CLOVERLEAF FILING NO. 2

A REPLAT OF A PORTION OF TRACT B, WOODMOOR PLACER

JOB NO. 25158.01
MAY 7, 2021
SHEET 1 OF 7

JOB NO. 25158.01
MAY 7, 2021
SHEET 2 OF 7

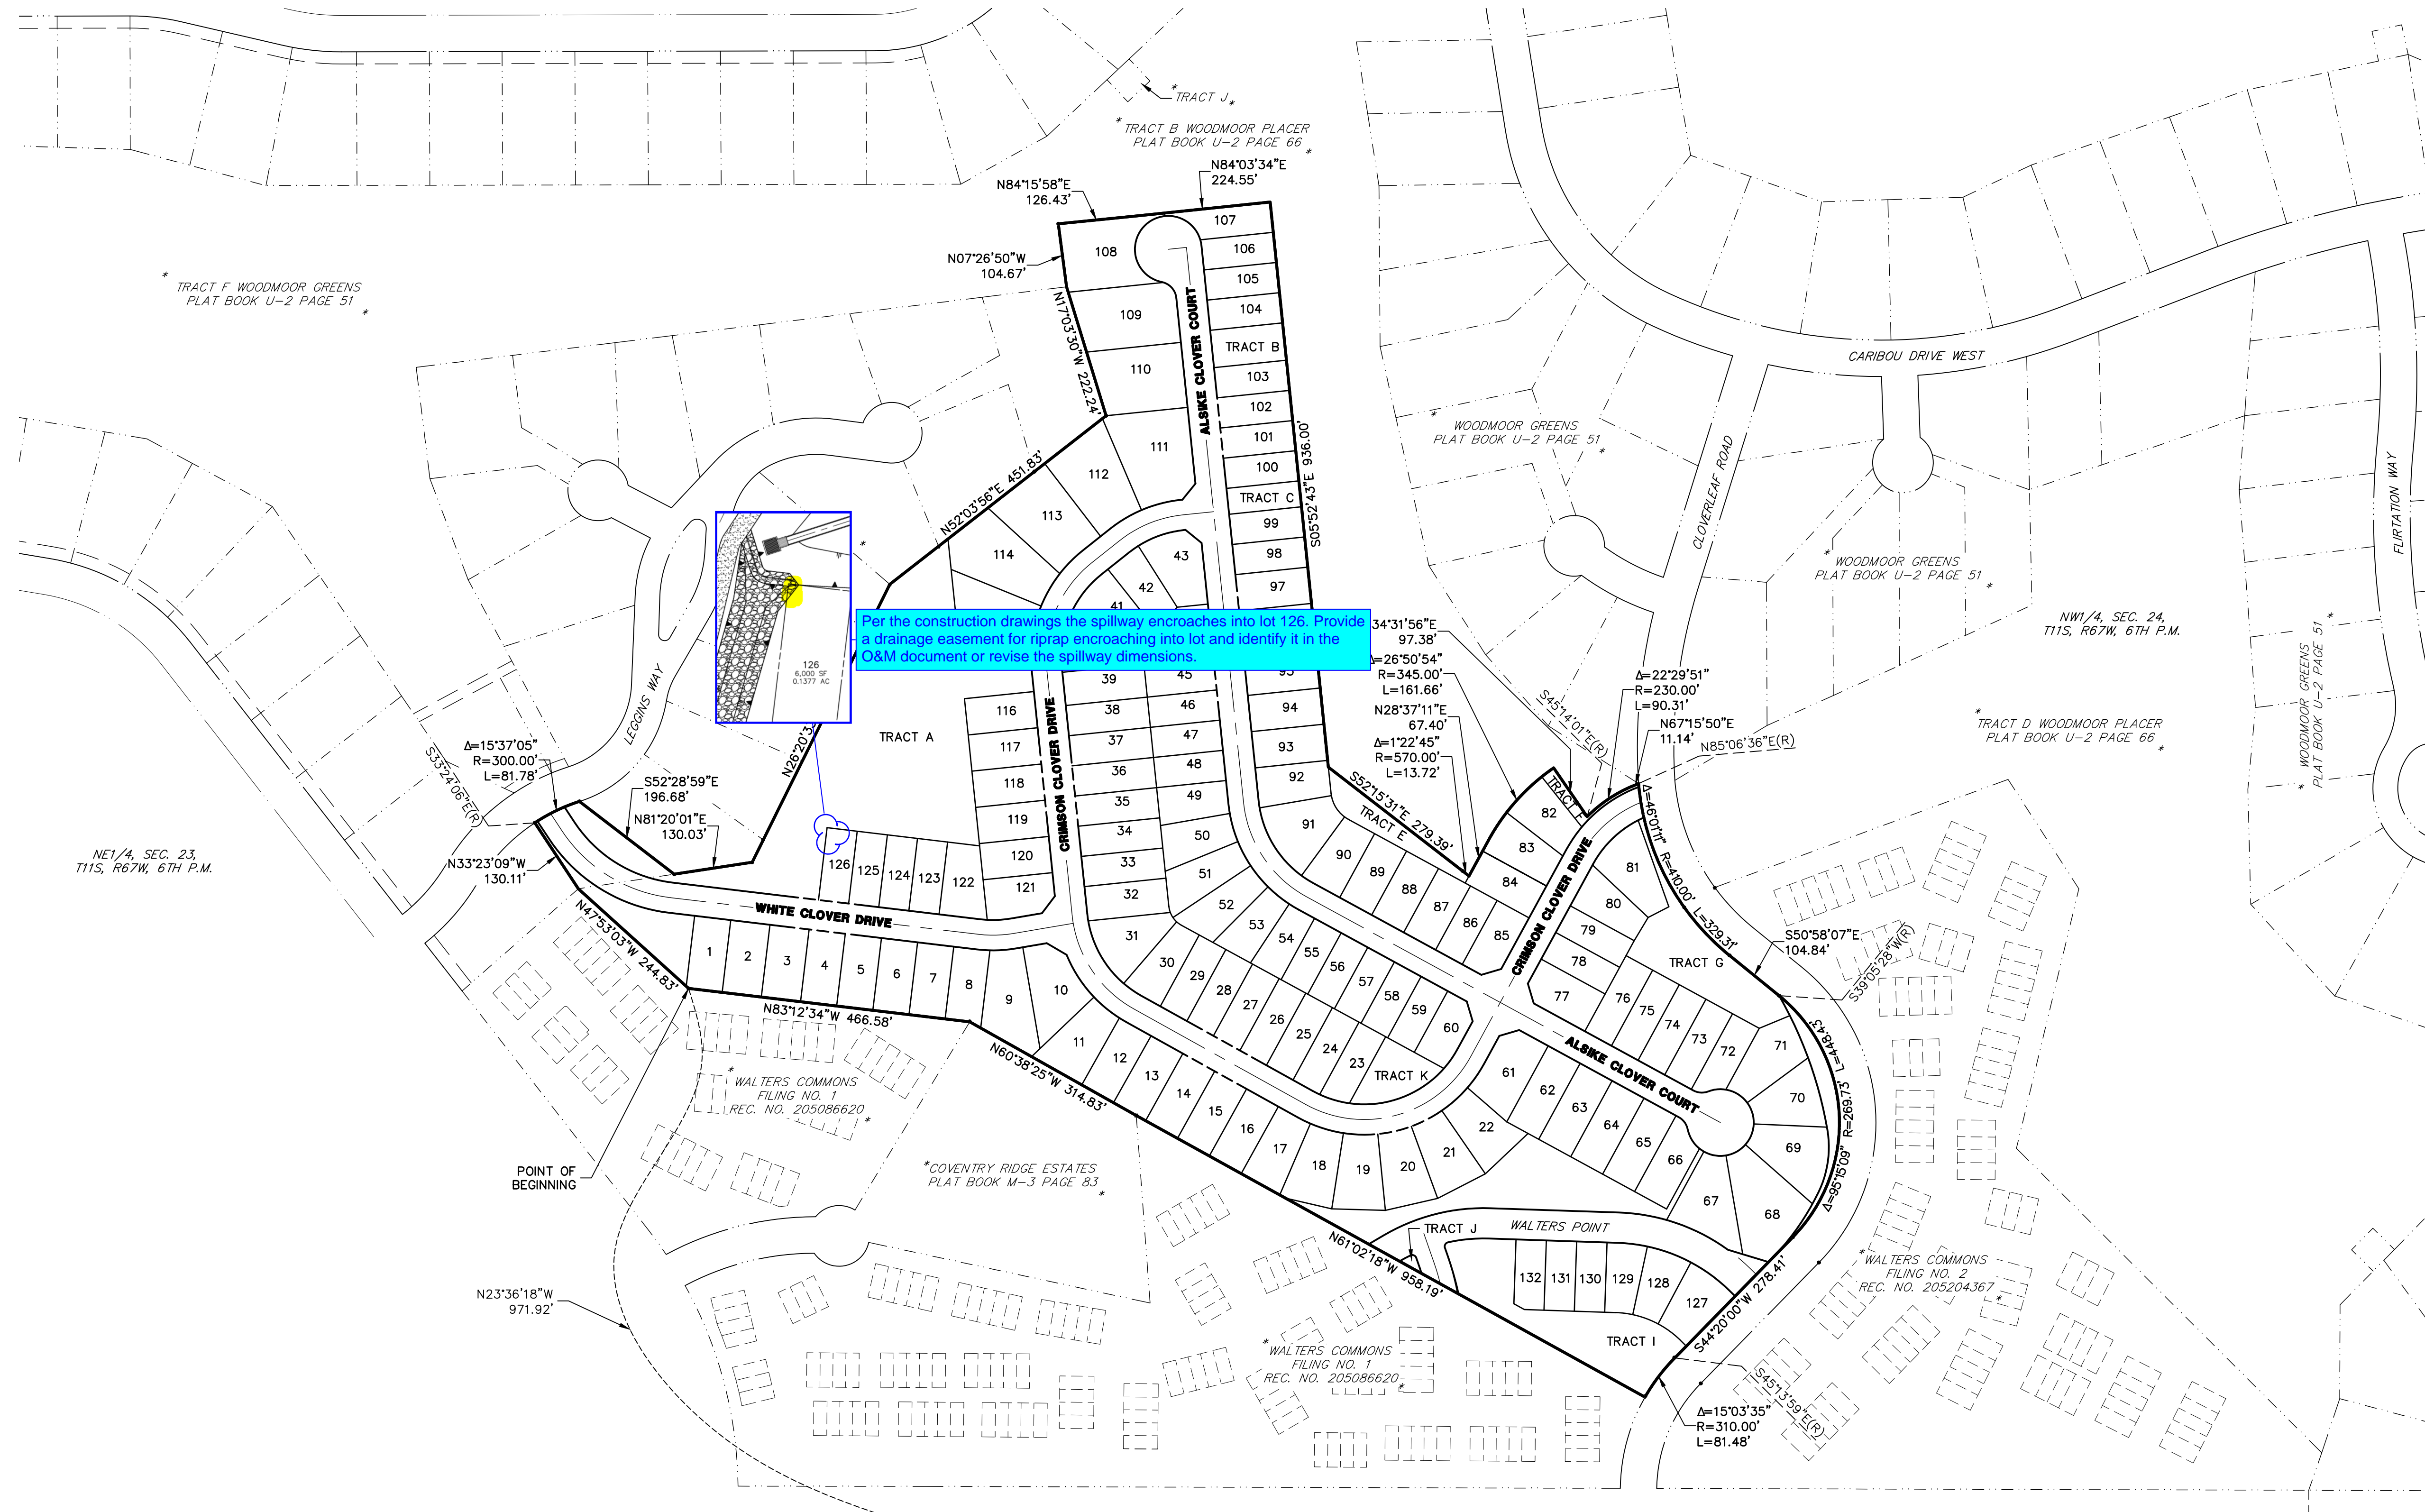
Show all floodplain, shallow groundwater, and geologic hazards dedicated on plat as no-build area and add corresponding notes.

JOB NO. 25158.01
MAY 7, 2021
SHEET 3 OF 7

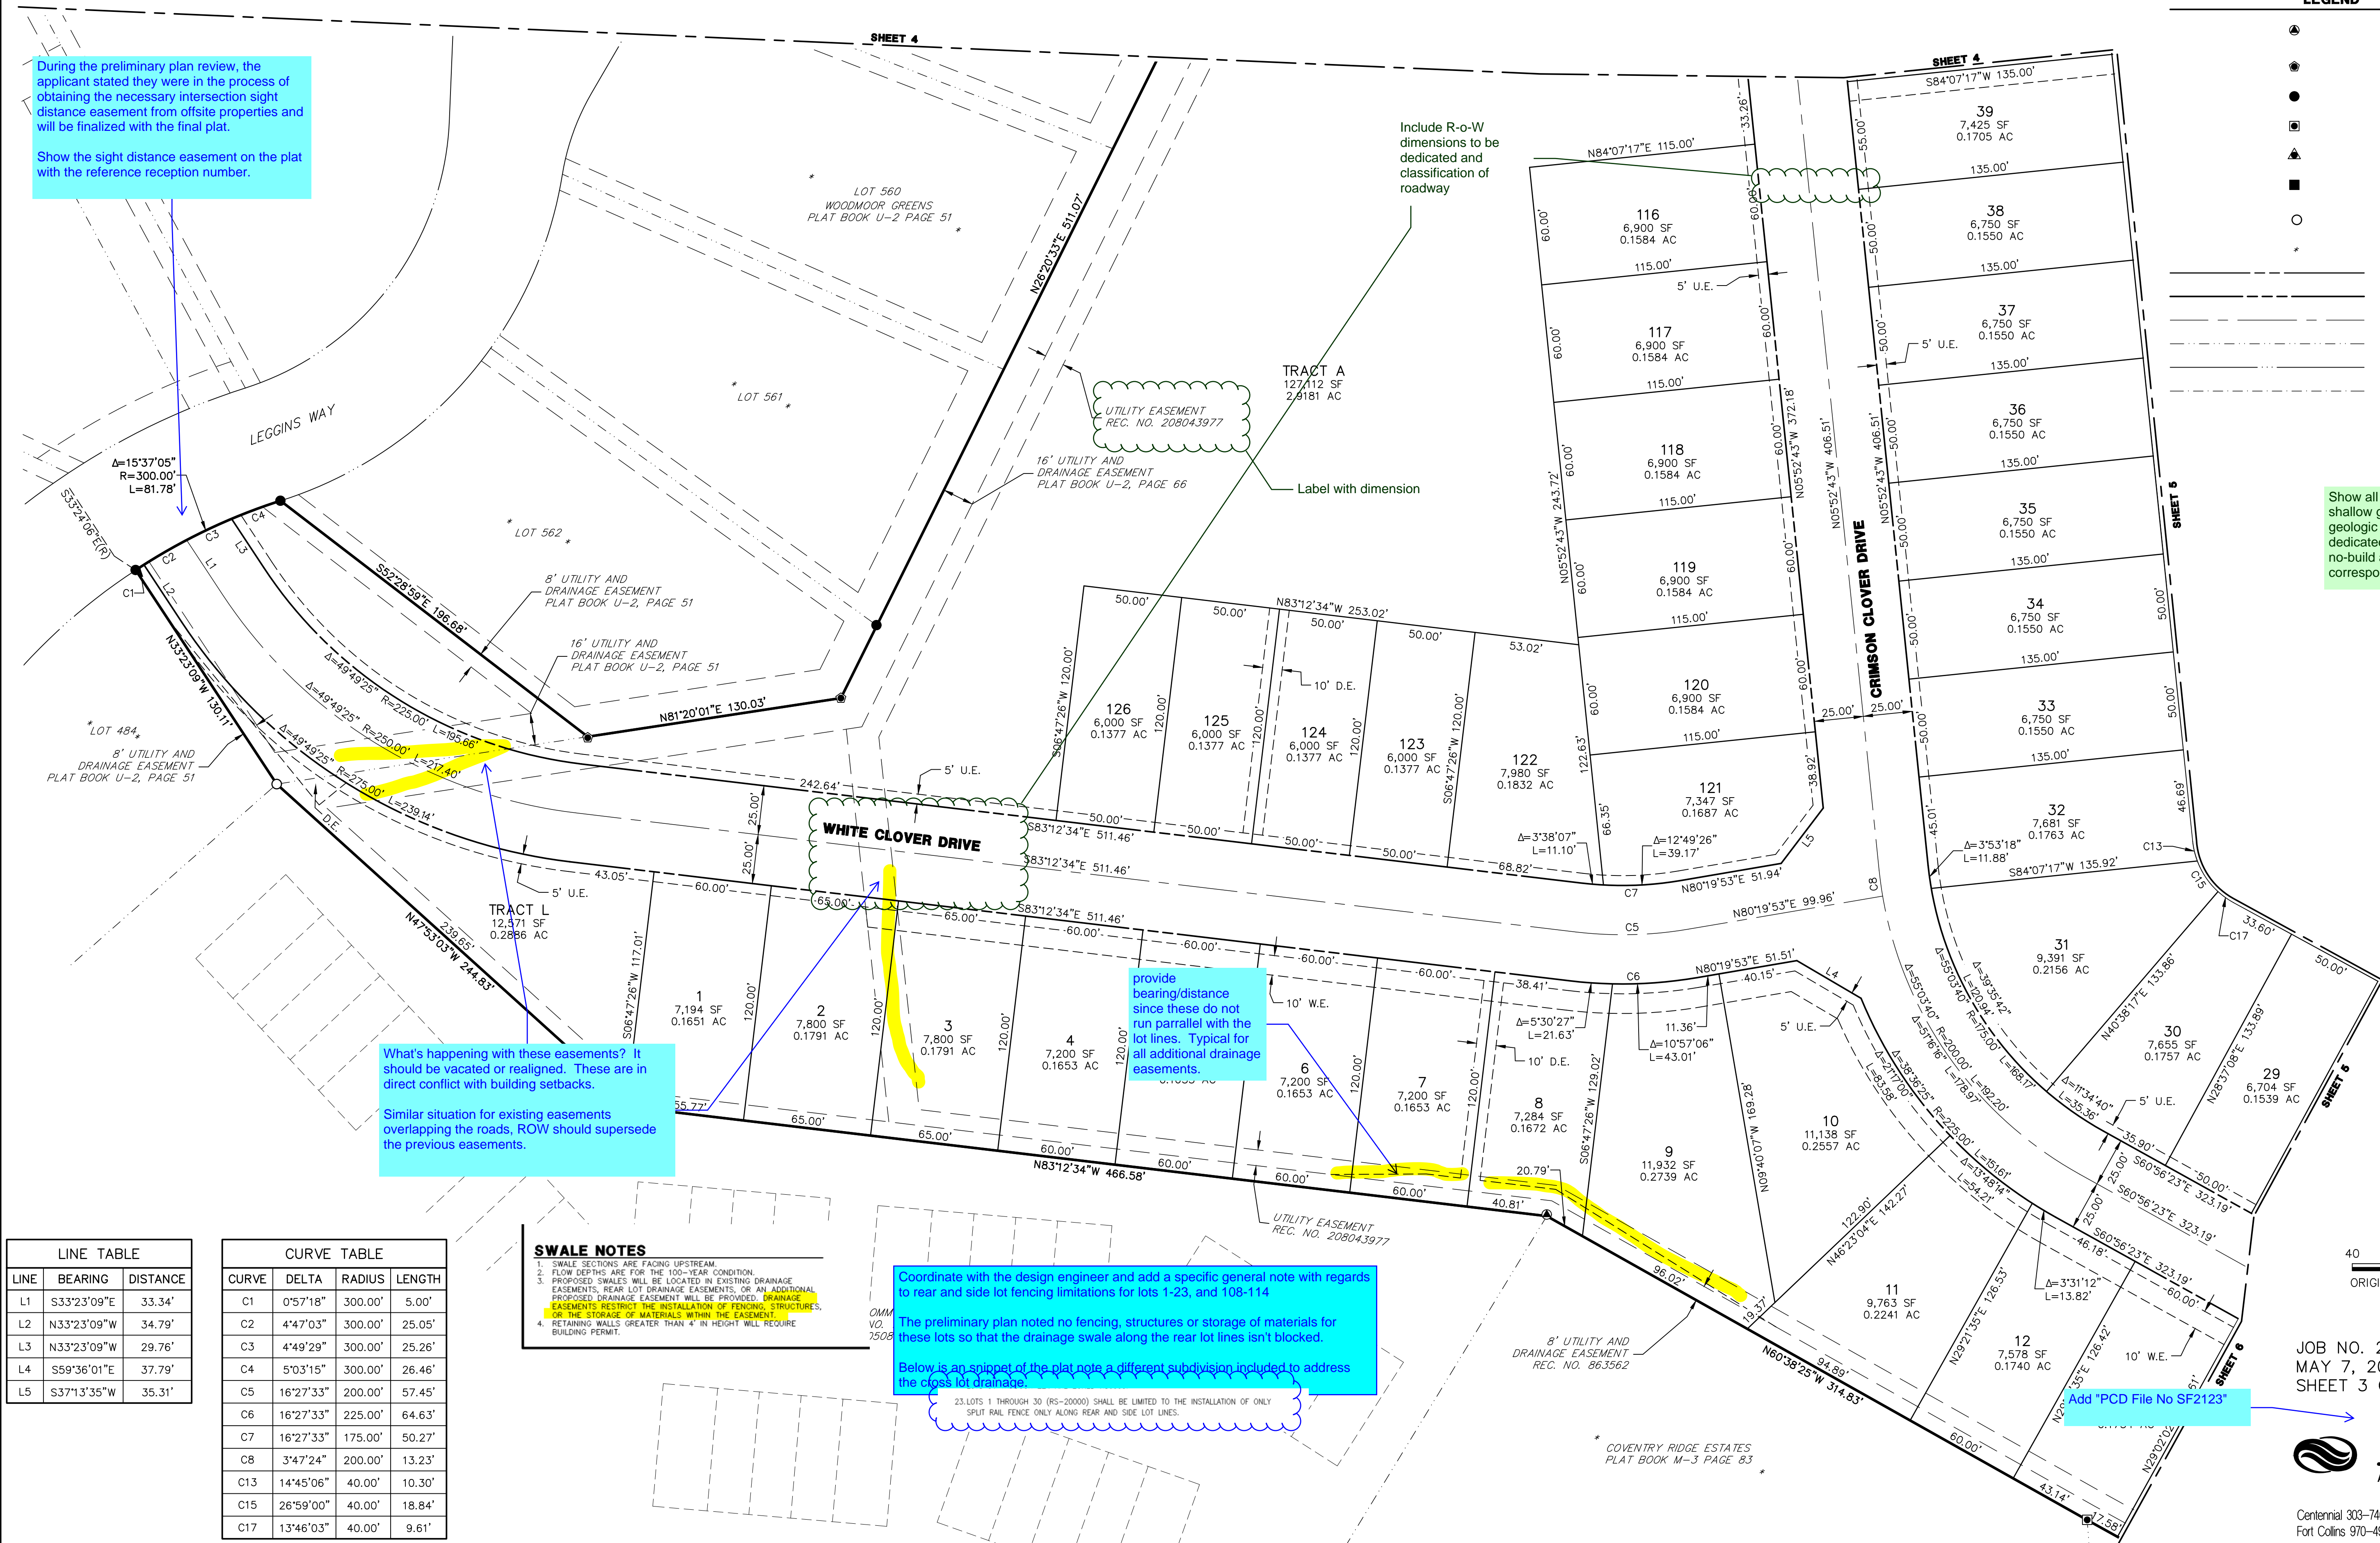
During the preliminary plan review, the applicant stated they were in the process of obtaining the necessary intersection sight distance easement from offsite properties and will be finalized with the final plat.

Show the sight distance easement on the plat with the reference reception number.

Show all floodplain, shallow groundwater, and geologic hazards dedicated on plat as no-build area and add corresponding notes.

JOB NO. 25158.01
MAY 7, 2021
SHEET 4 OF 7

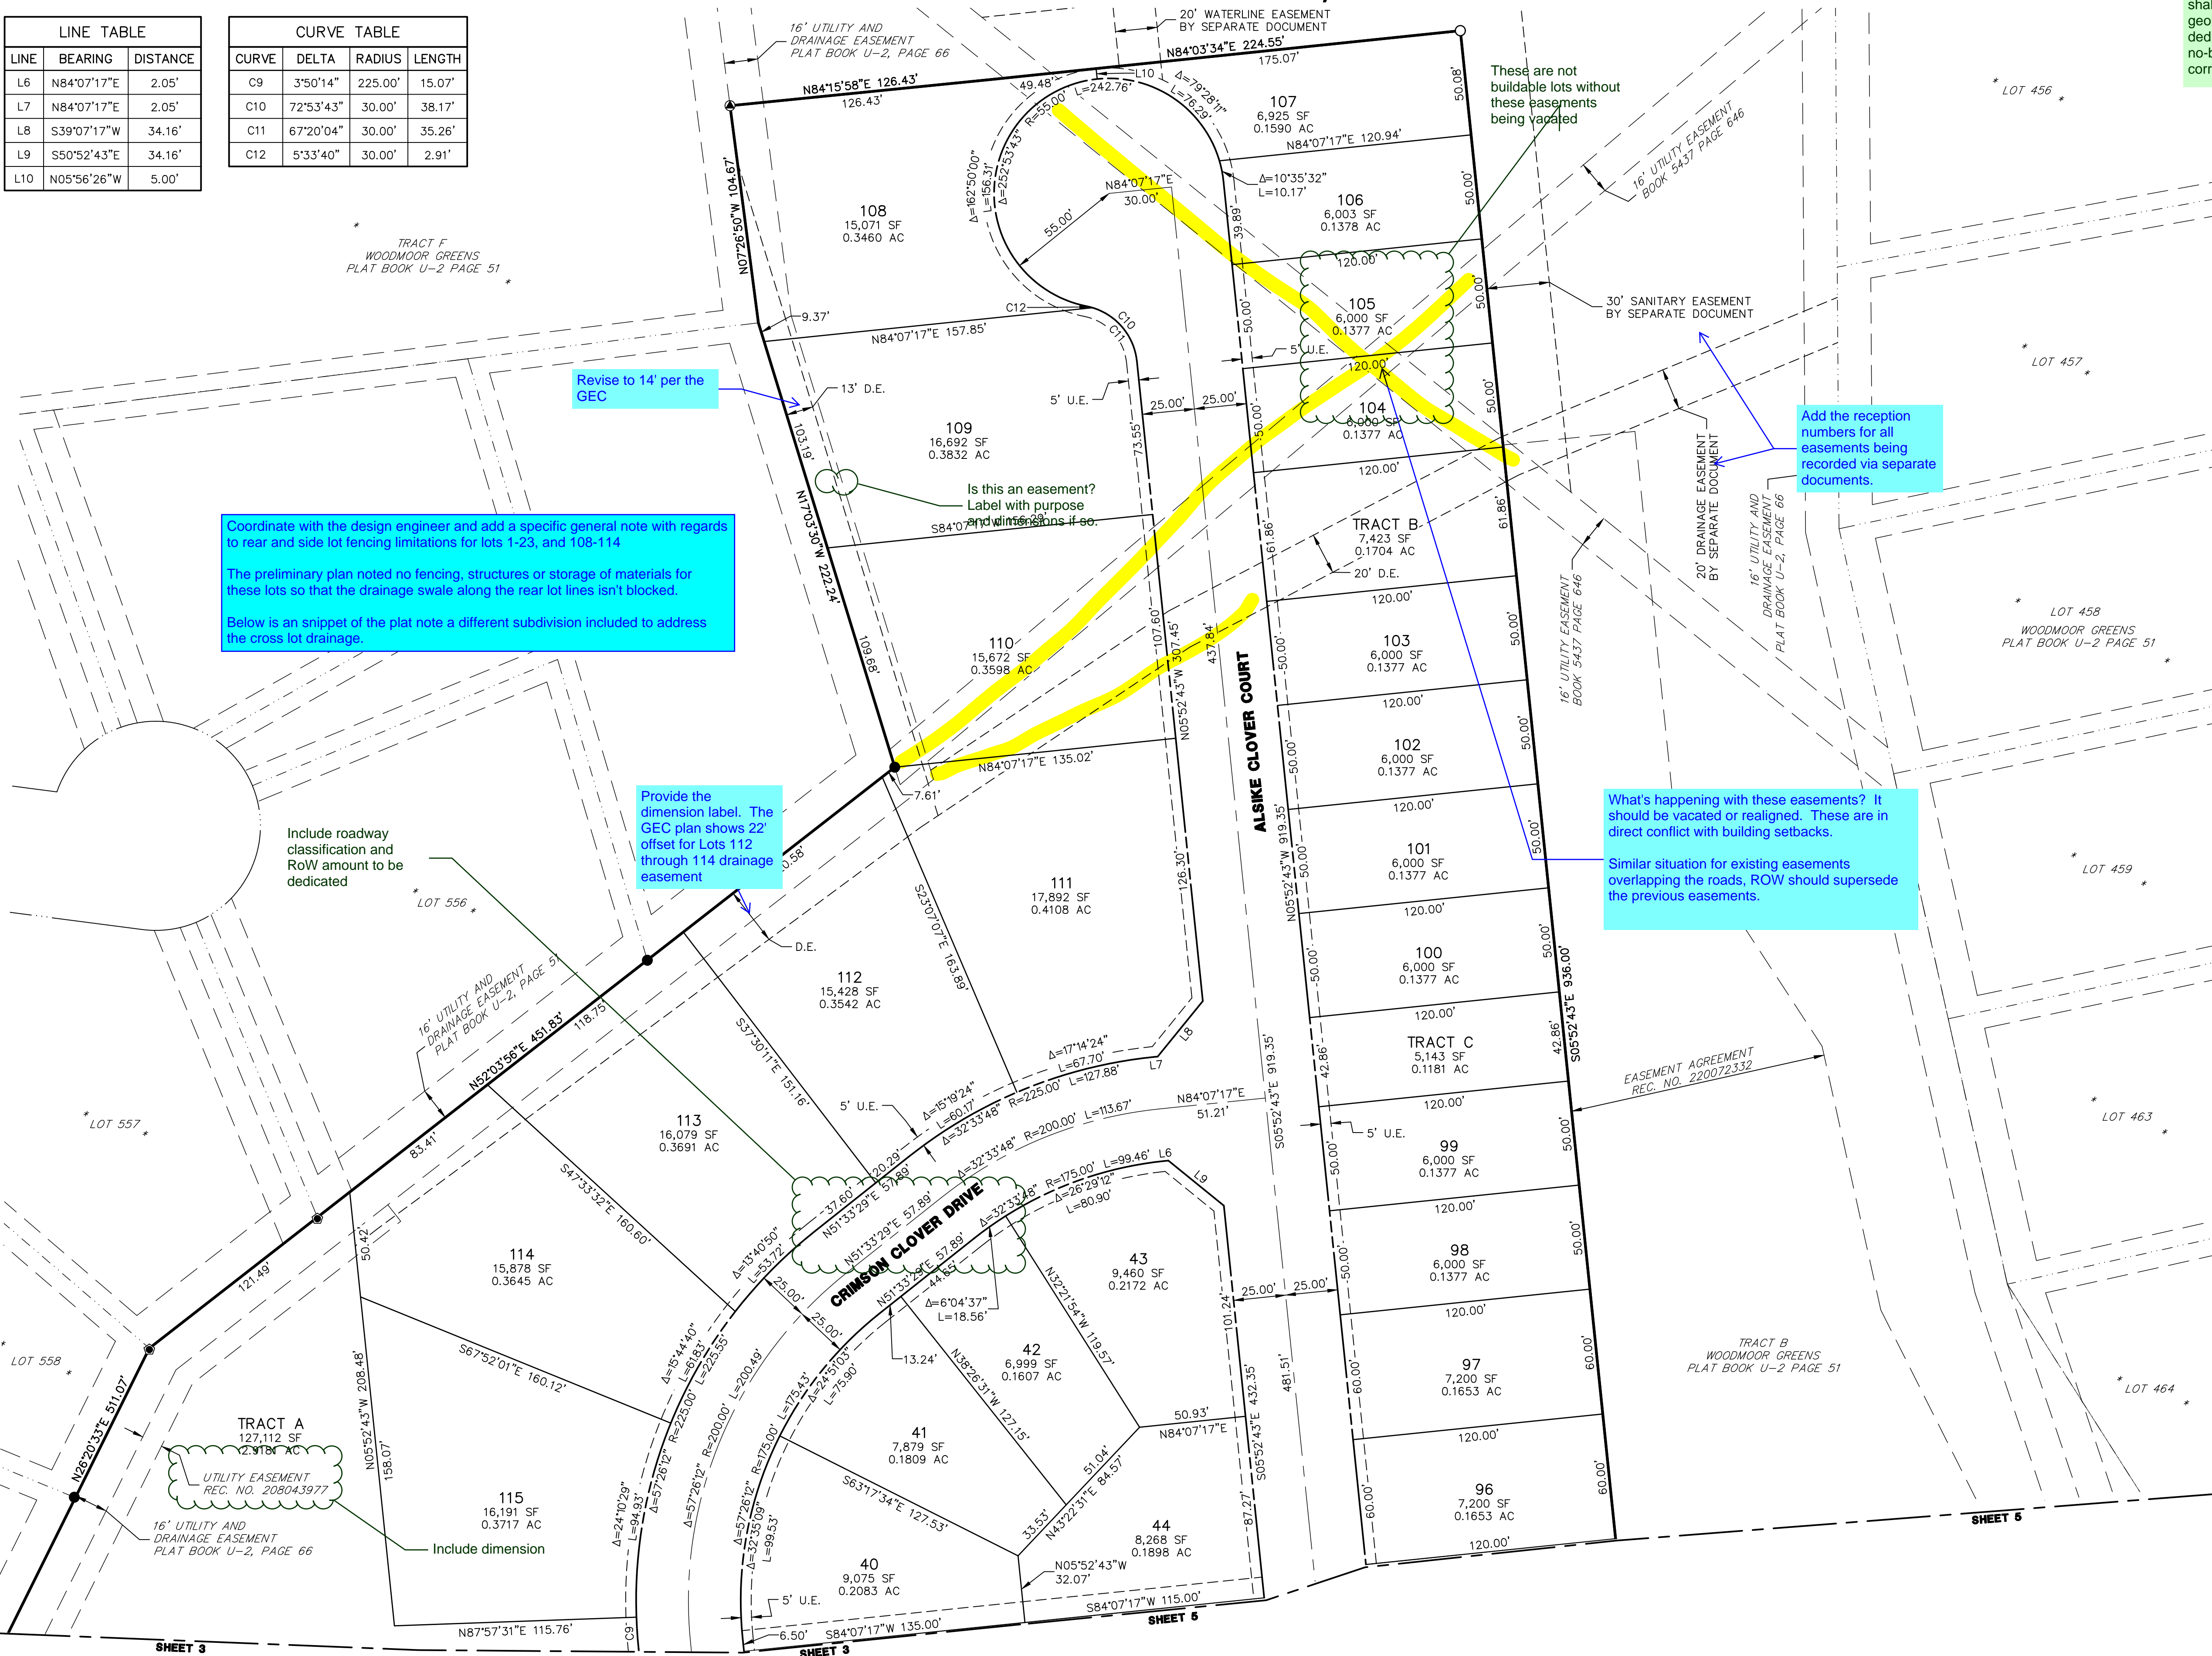
Show all floodplain, shallow groundwater, and geologic hazards dedicated on plat as no-build area and add corresponding notes.
